APPLICATION NO.	FILING DATE	FIRST NAMED INVENTOR	ATTORNEY DOCKET NO.	CONFIRMATION NO.
10/809,448	03/26/2004	Takashi Ohama	119302	8136
25944 OLIFF & BERI	7590 01/23/200 RIDGE, PLC	EXAMINER		
P.O. BOX 3208	350	MCCULLOUGH, MICHAEL C		
ALEXANDRIA	A, VA 22320-4850		ART UNIT	PAPER NUMBER
			3653	
			MAIL DATE	DELIVERY MODE
			01/23/2008	PAPER

DETAILED ACTION

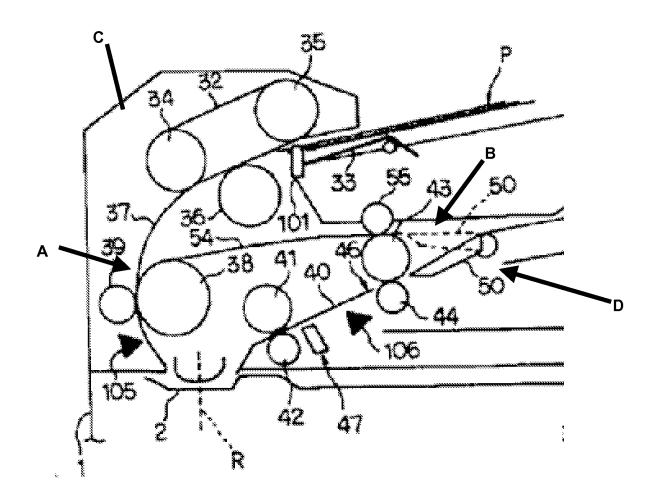
- 1. Claims 1-13, 29-31, 35, and 36 are rejected under 35 U.S.C. 103(a) as being unpatentable over Tetsuo (JP 10-268442) in view of Sugiyama et al. (US 2002/0030321). Tetsuo discloses a transport path with a first route (37), a joining position (see Figure 2 element A, below), a reading position with an opening (2), a transport changing position (see Figure 2 element B, below), an inversion-and-transport path including a second route (54), a document transporting unit (43, 44), a closed portion (54), a document length detecting unit (105), a controlling unit and first comparing unit (see Abstract) which determines whether the document is to be transported to the inversion-and-transport path or not on the basis of a result of the comparison by the first comparing unit, a document discharging portion (see Figure 2 element D, below) disposed at the transport changing position, and a cover member (see Paragraph 0021 and element C, below).
